Access Compliance Report

Public Rights-of-Way

Intersection ID: 10024974	Main Street: DIXIE_RIVER_RD	Cross Street: N/A	Location: N
ADA ID: DC967C041F27	Ramp Type: Perp	Initial Pass/Fail: Fail	Overall Compliance: No
			Severity Score: 21.25

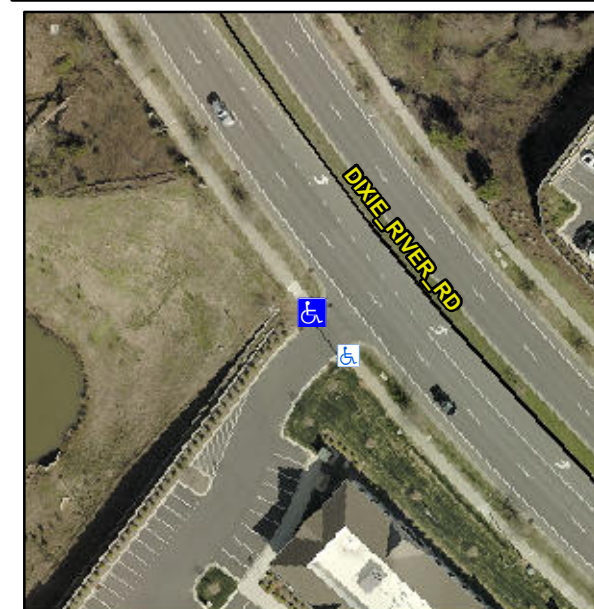
Not Found, R304.5.1, R304.2.2

Compliance	Description	Data	Compliance	Description	Data
N/A	Ramp Length (in)	62.0	No	Ramp Slope (%)	9.0
No	Ramp Width (in)	46.0	Yes	Ramp XSlope (%)	1.0
N/A	Flare Type LT	N/A	N/A	Flare Type RT	N/A
N/A	Flare Slope LT (%)	N/A	N/A	Flare Slope RT (%)	N/A
N/A	Flare Traversable LT?	N/A	N/A	Flare Traversable RT?	N/A
N/A	Landing Length (in)	N/A	N/A	DWS Provided?	N/A
N/A	Landing Width (in)	N/A	N/A	DWS Contrast?	N/A
N/A	Landing Slope (%)	N/A	N/A	DWS Length (in)	N/A
N/A	Landing X Slope (%)	N/A	N/A	DWS Full Width?	N/A
N/A	Landing Curb? (Y/N)	N/A	N/A	DWS Offset (in)	N/A
N/A	Shared Landing?	N/A			
N/A	Gutter Ponding?	N/A	N/A	Gutter Slope (%)	N/A
N/A	Gutter Lip Ht (in)	N/A	N/A	Gutter X Slope (%)	N/A
N/A	Painted X Walk1?	No	N/A	Painted X Walk2?	N/A
	X Walk 1 Direction	To S		X Walk 2 Direction	N/A
N/A	X Walk 1 Width (in)	N/A	N/A	X Walk 2 Width (in)	N/A
	X Walk 1 Slope (%)	3.4		X Walk 2 Slope (%)	N/A
	X Walk 1 X Slope (%)	1.1		X Walk 2 X Slope (%)	N/A

Remove & Replace Entire Ramp.
